UNITED STATES PATENT AND TRADEMARK OFFICE

APPLICATION NO.	FILING DATE	FIRST NAMED INVENTOR	ATTORNEY DOCKET NO.	CONFIRMATION NO.
10/816,252	04/02/2004	David Walter Wright	115624	8511
25944	7590	01/05/2011		
OLIFF & BERRIDGE, PLC P.O. BOX 320850 ALEXANDRIA, VA 22320-4850			EXAMINER BOWERS, NATHAN ANDREW	
			ART UNIT	PAPER NUMBER
			1775	
			NOTIFICATION DATE	DELIVERY MODE
			01/05/2011	ELECTRONIC

Office Action Summary	Application No.	Applicant(s)	
	10/816,252	WRIGHT ET AL.	
	Examiner	Art Unit	
	NATHAN A. BOWERS	1775

DETAILED ACTION

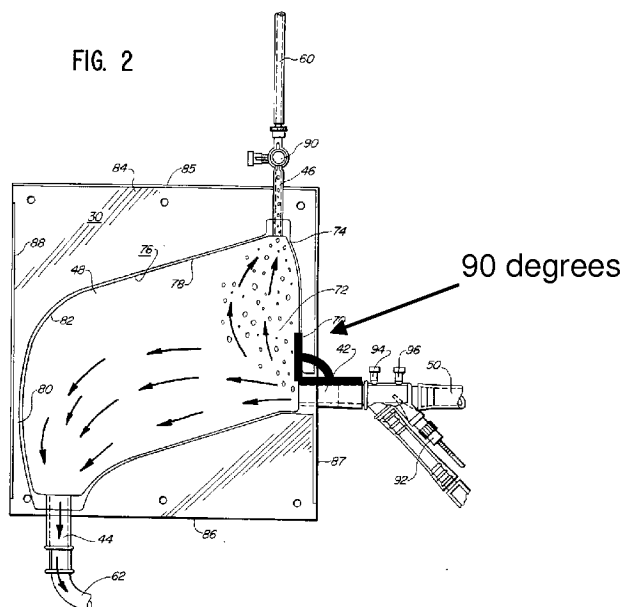
Although Figure 2 suggests that the second chamber opening is located at the top portion of the chamber, it is not entirely clear whether the second chamber opening is located in the *middle* of the top portion. From Figure 2, it appears that the second

chamber opening is located at one side of the top portion. However, it would have been obvious to ensure that the second chamber opening of Viitala is located in a middle-portion of a top portion. This would represent a mere rearrangement of parts that would not affect the functionality of the device, and instead would only represent a cosmetic design choice. Viitala does not disclose any teachings that require the second chamber opening to be positioned at one side of the top portion. Viitala only states in column 3, lines 22-25 that the sidewall (Figure 2:70) leading to the second chamber opening must be at a sharp right angle with the first chamber opening, but says nothing about the placement of the second chamber opening.

Therefore, one of ordinary skill would have found it obvious to position the second chamber opening anywhere along the top portion of the chamber. This is especially true in light of Oshiyama.

Accordingly, one of ordinary skill would have recognized that the Viitala reference could be modified to provide a second chamber opening in a middle portion of the top portion while still maintaining the sidewall (Figure 2:70) leading to the second chamber opening at a sharp right angle with the first chamber opening.

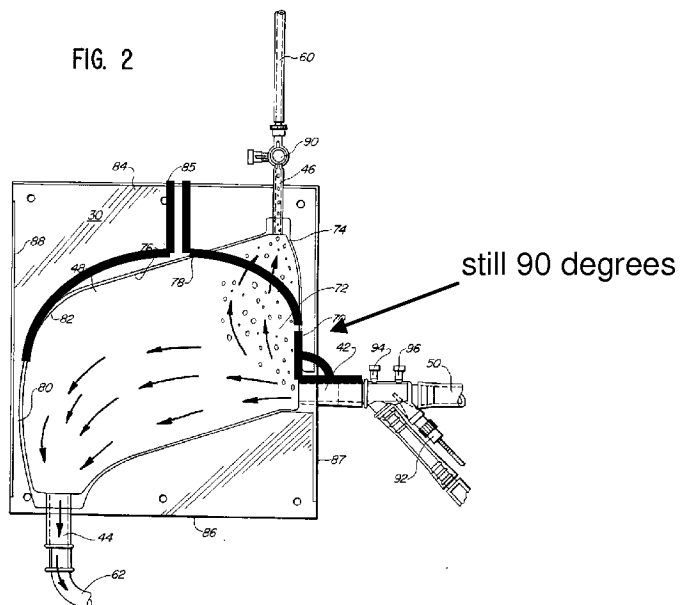
Oshiyama discloses an apparatus for separating gas from a liquid path comprising a chamber (Figure 1:12) having a top, bottom and side walls. A first opening (Figure 1:15) allows gas and liquid to enter the chamber, a second opening (Figure 1:18) is configured to allow gas to exit the chamber, and a third opening (Figure 1:17) is configured to allow liquid to exit the chamber. This is taught in column 4, line 41 to column 6, line 22. Oshiyama discloses a plurality of embodiments (see Figure 1 and 3, for example) in which the second chamber opening is positioned varying locations along the top portion.

Viitala additionally teaches that third chamber opening is at a bottom portion of the chamber. Vittala, however, does not expressly teach that the third chamber opening is at a *middle* portion of the bottom.

Oshiyama discloses an apparatus for separating gas from a liquid path comprising a chamber (Figure 1:12) having a top, bottom and side walls. A first opening (Figure 1:15) allows gas and liquid to enter the chamber, a second opening (Figure 1:18) is configured to allow gas to exit the chamber, and a third opening (Figure 1:17) is configured to allow liquid to exit the chamber. This is taught in column 4, line 41 to column 6, line 22. Column 5, lines 45-62 state that the third opening is located in a middle portion of the chamber bottom when $L_2/L = 0.5$ (see Figure 1).

At the time of the invention, it would have been obvious to provide the third chamber opening of Viitala at a middle portion of bottom of the chamber rather than to one side. Oshiyama teaches a similar debubbler bag configuration that successfully removes air from a blood stream, wherein the third chamber opening for removing air-free blood is at a middle portion of the chamber bottom. Accordingly, one of ordinary skill would have recognized that a successful gas separating procedure could likewise be completed in the Viitala apparatus if the Viitala third chamber opening was located at the middle of the chamber bottom.

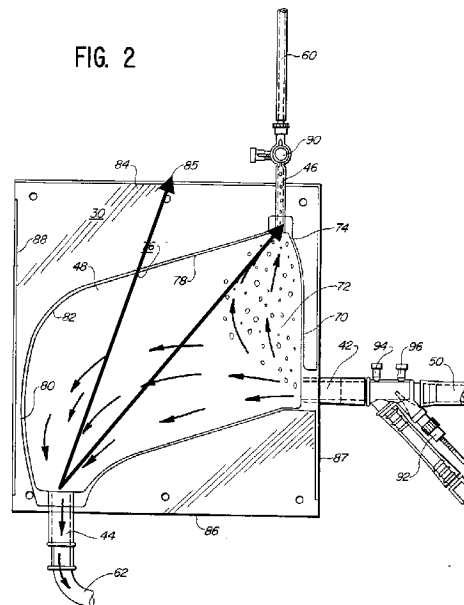
The majority of Applicant's arguments have been fully addressed in previous Office Actions. It is additionally noted that one of ordinary skill in the art would have been able to modify the Viitala apparatus in the manner proposed in the rejections above while still allowing "the outlet 44 [to be] diagonally spaced as far as possible from vent 46" simply by moving vent 46 closer to the top of the housing.

Outlet vent 46 could easily be moved to the center of the chamber while still maintaining approximately the same diagonal distance between outlet vent 44 and outlet vent 46.
